ADDENDUM 03, DELTA 03 DATE 05.01.2026

PROJECT: Santa Rosa Freestanding Emergency Room

ARCHITECT'S PROJECT NUMBER:
225014.00

OWNER: HCA Florida Fort Walton-Destin Hospital

1 MED GAS - FIRST FLOOR PLAN - NEW WORK
SCALE: 1/8" = 1'-0"

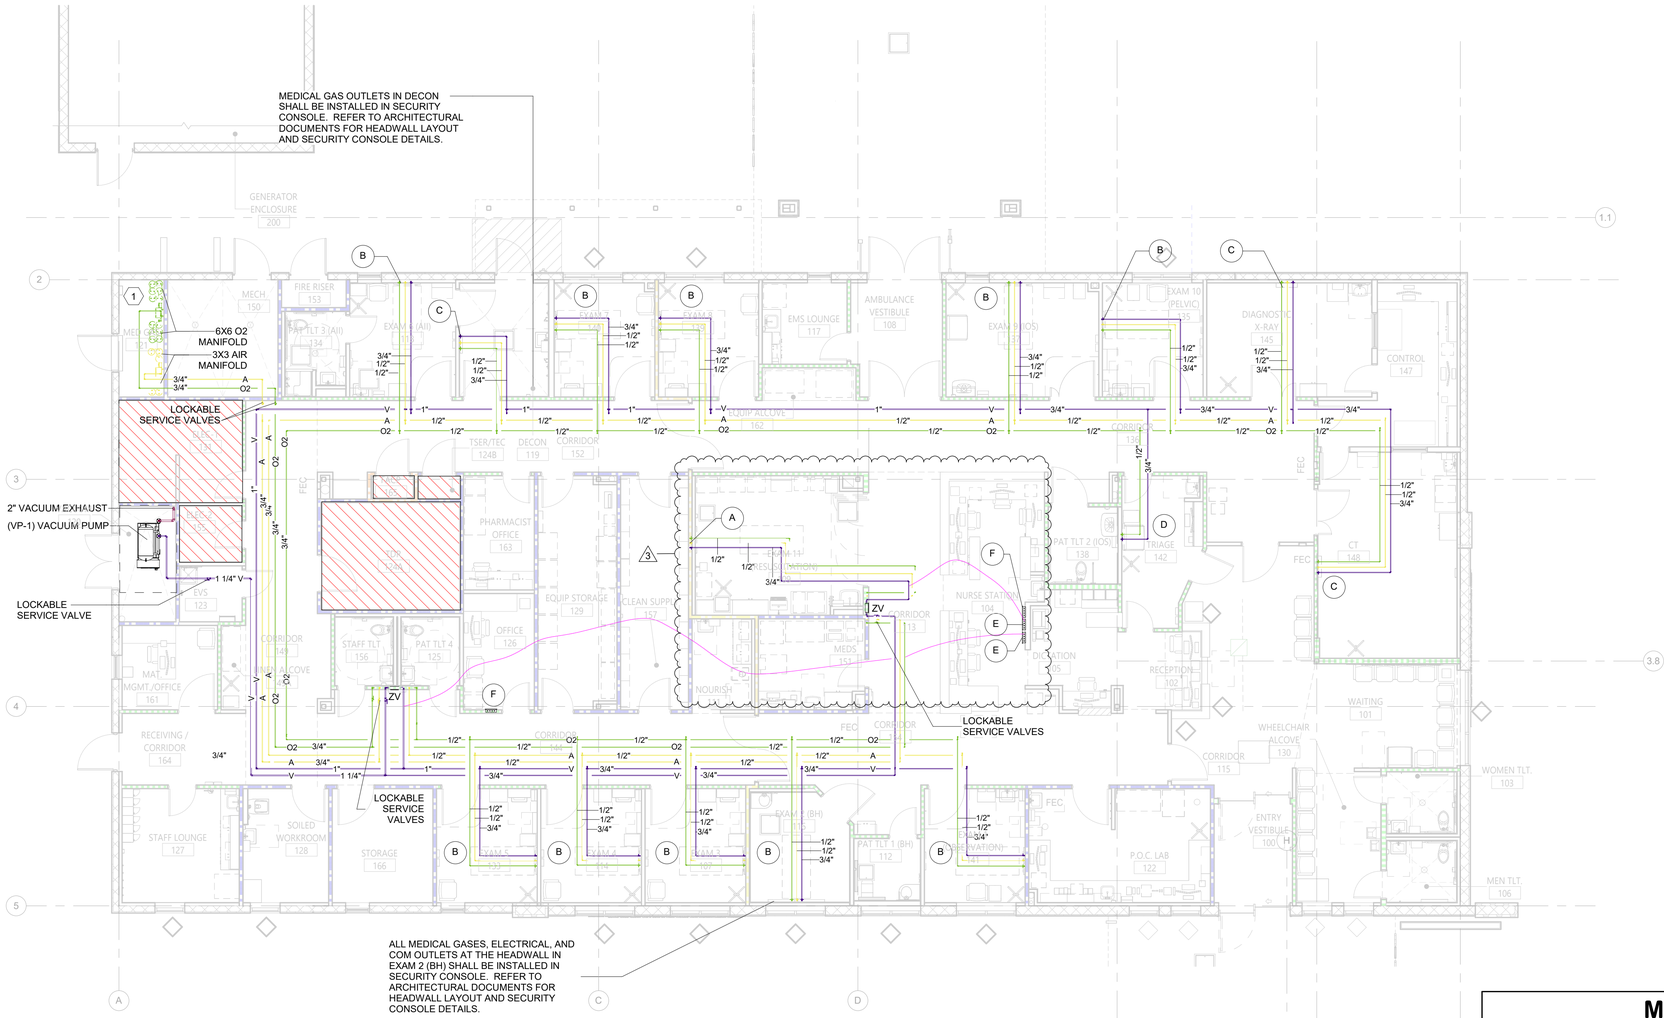
1. Revised resuscitation medical gas zone valve box and piping to accommodate floor plan changes per architectural coordination.

1 DOMESTIC WATER RISER.
SCALE:

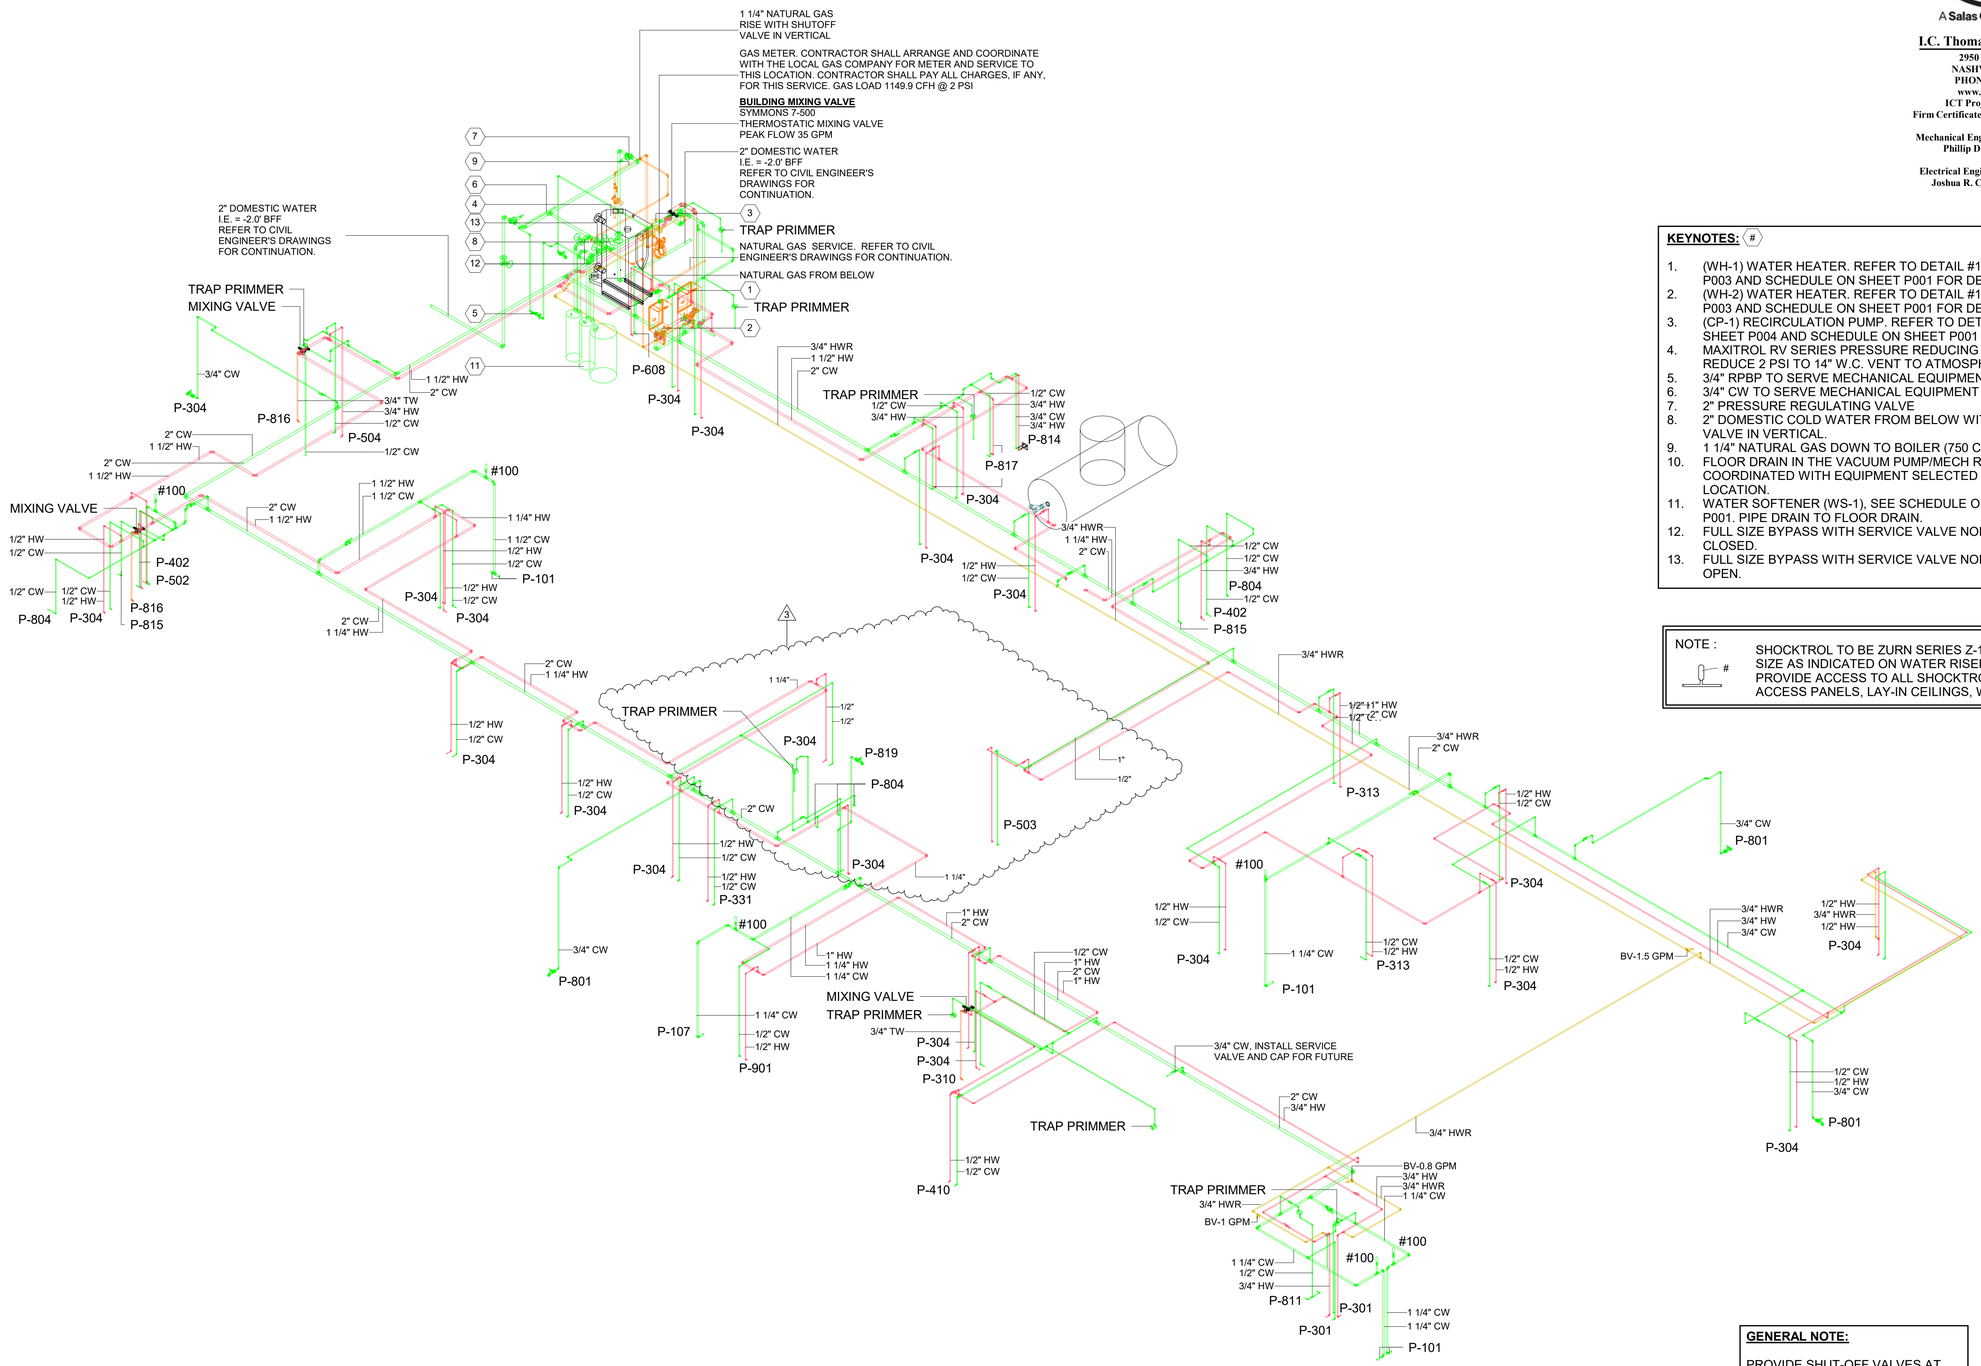
1. Revised domestic hot and cold water routing to accommodate floor plan changes per architectural coordination.

1 P403 MED GAS

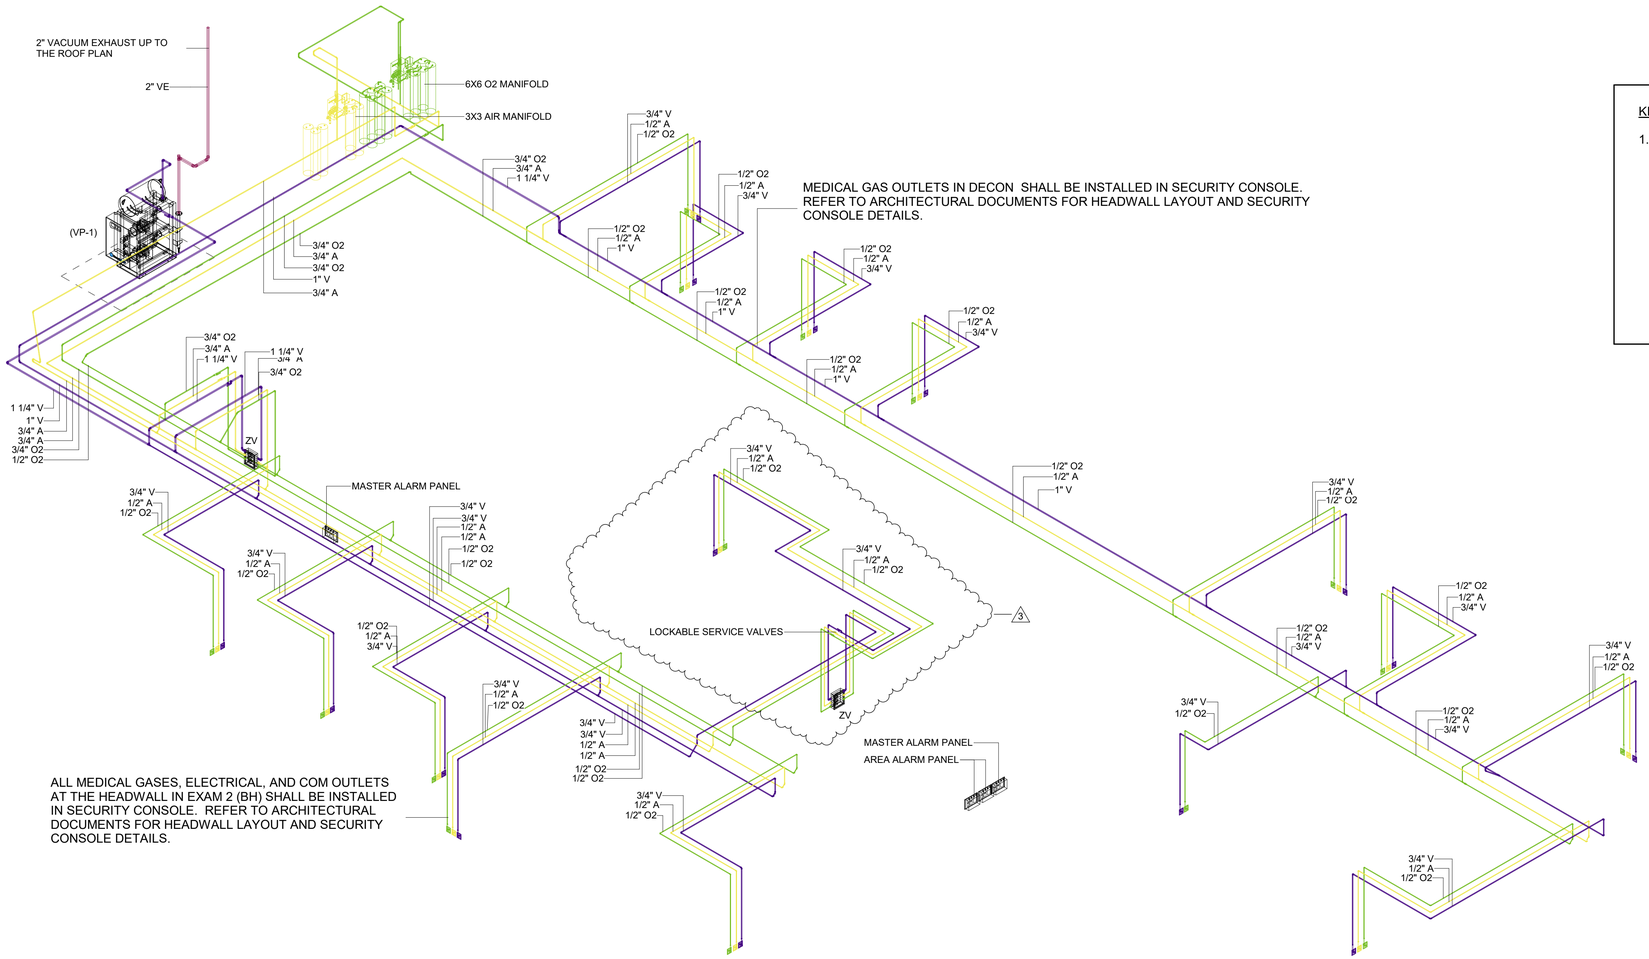
1. Revised resuscitation medical gas zone valve box and piping to accommodate floor plan changes per architectural coordination.

1 HVAC - FIRST FLOOR PLAN
SCALE: 1/8" = 1'-0"

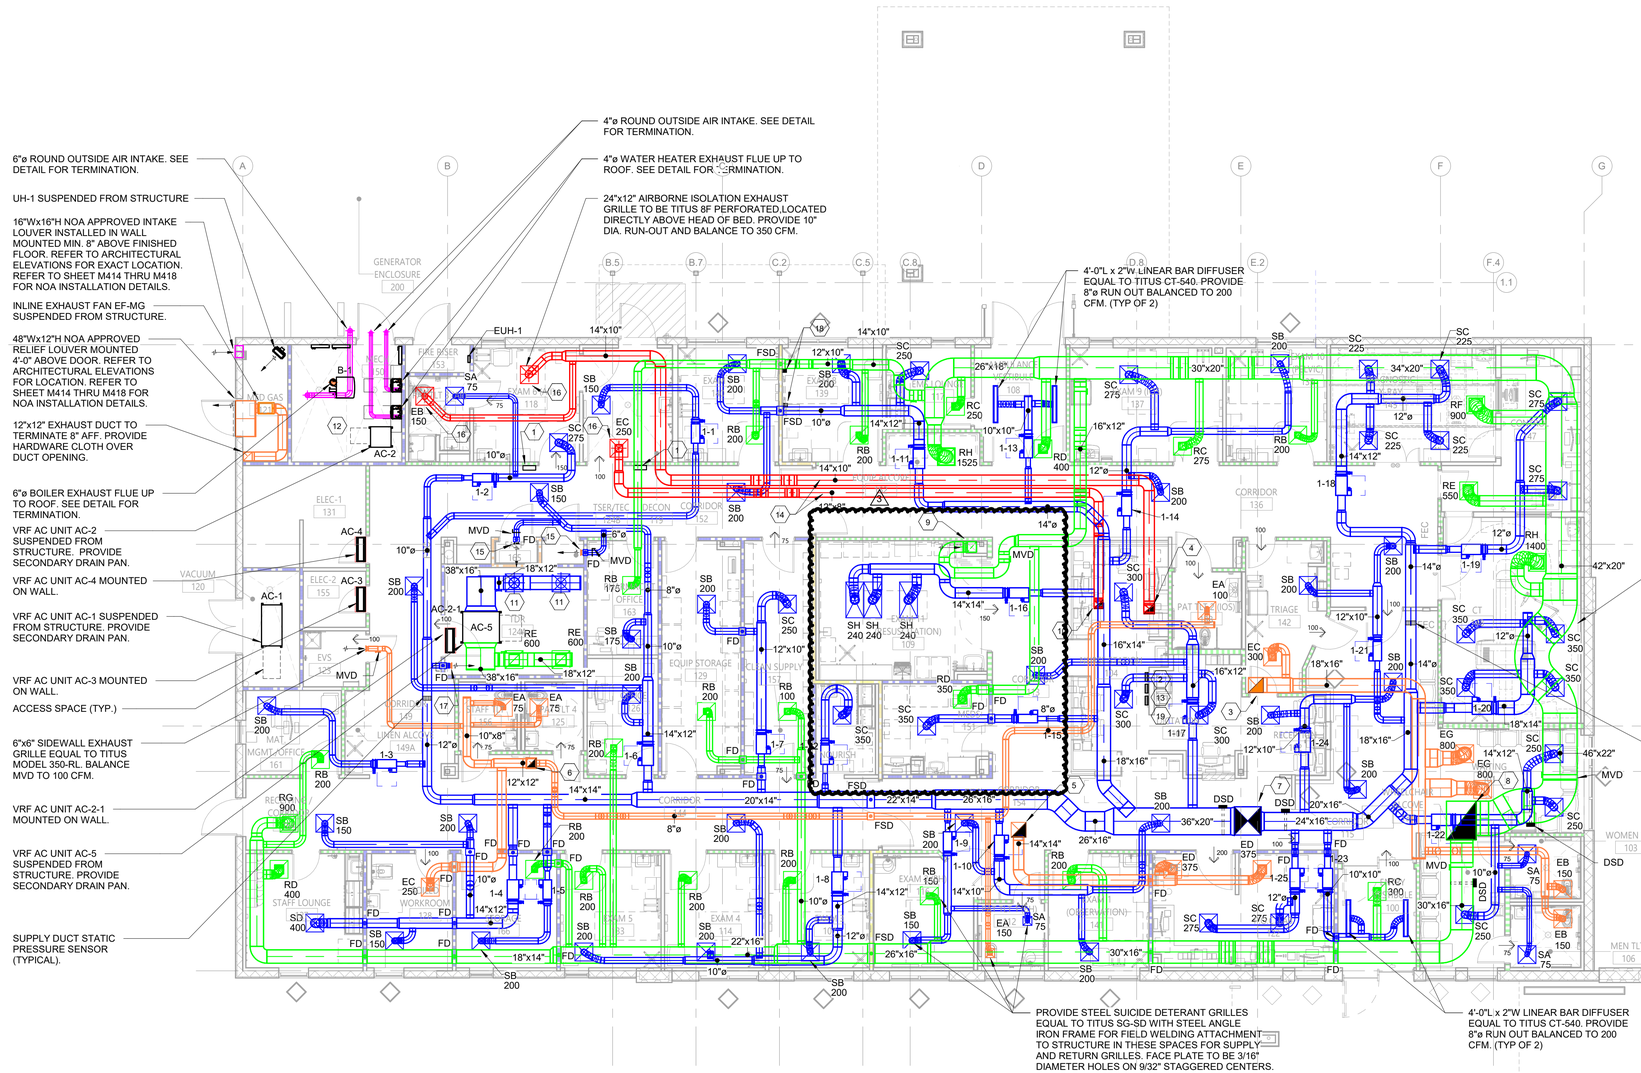
1. Revised duct and VAV layout to match architectural floor plan changes

1 HVAC PIPING - FIRST FLOOR PLAN
SCALE: 1/8" = 1'-0"

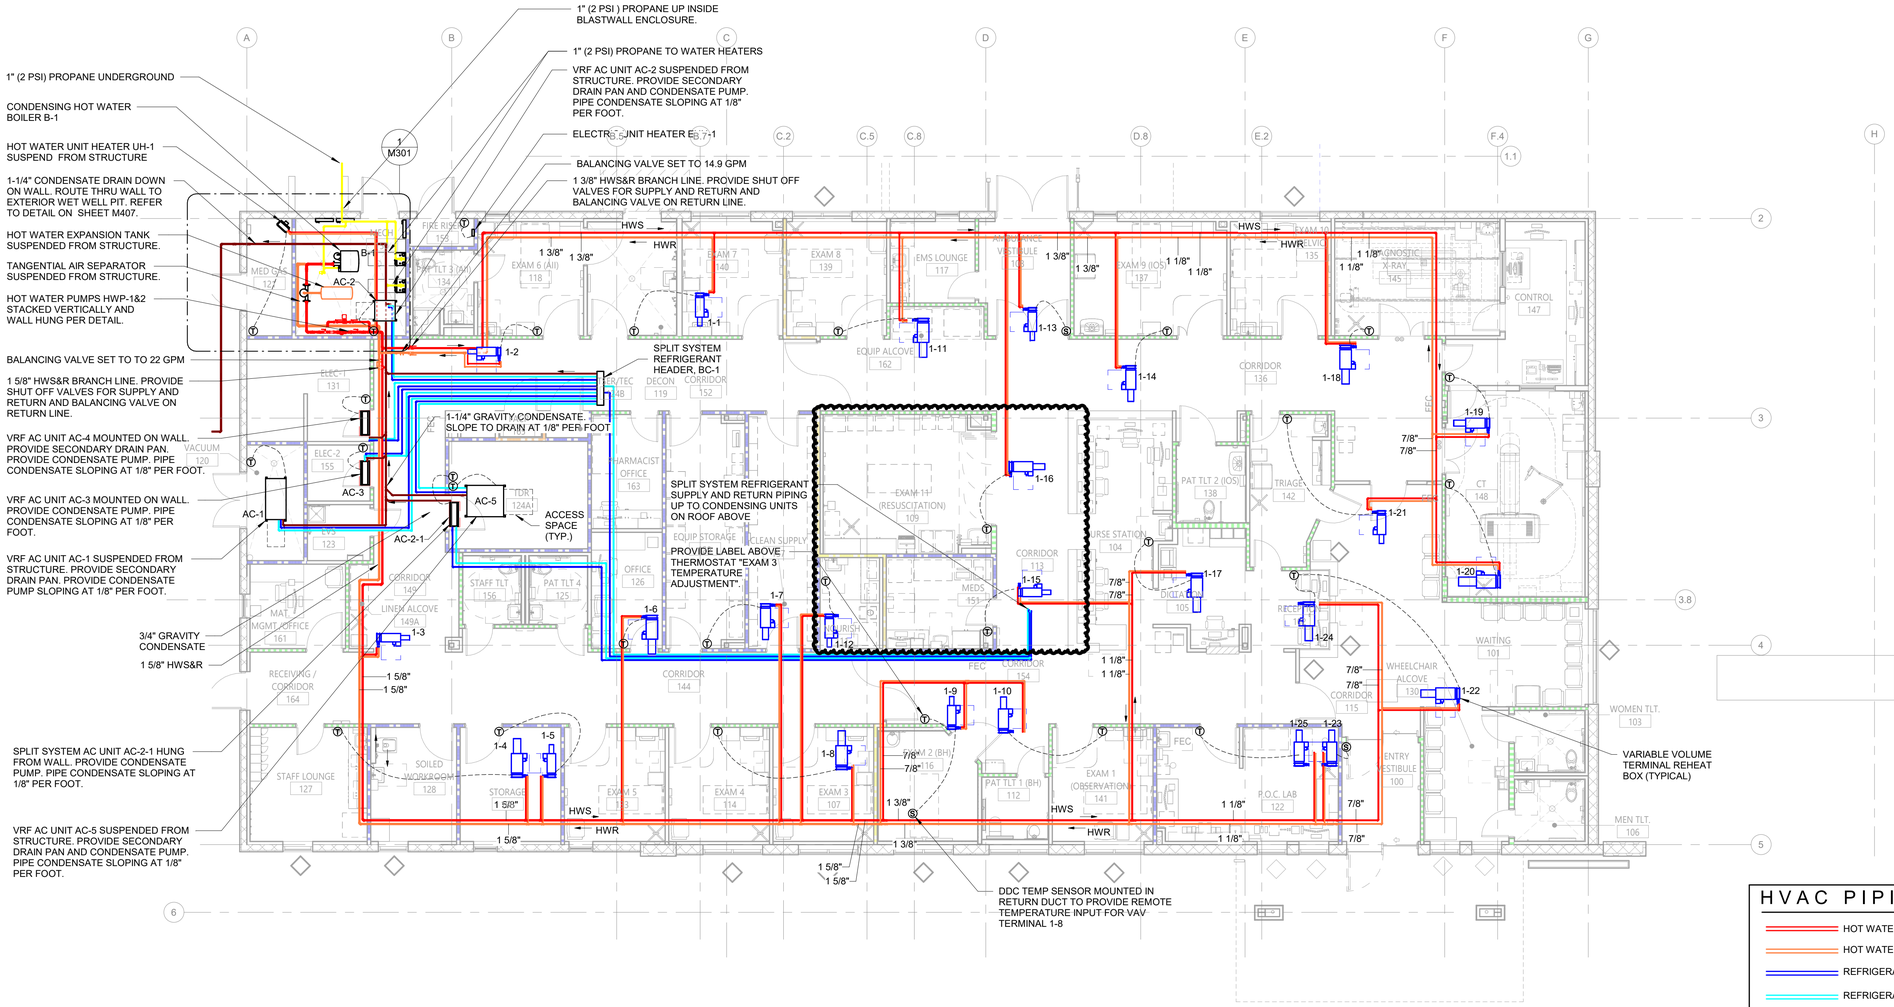
1. Revised piping, thermostat, and VAV layout to match architectural floor plan changes
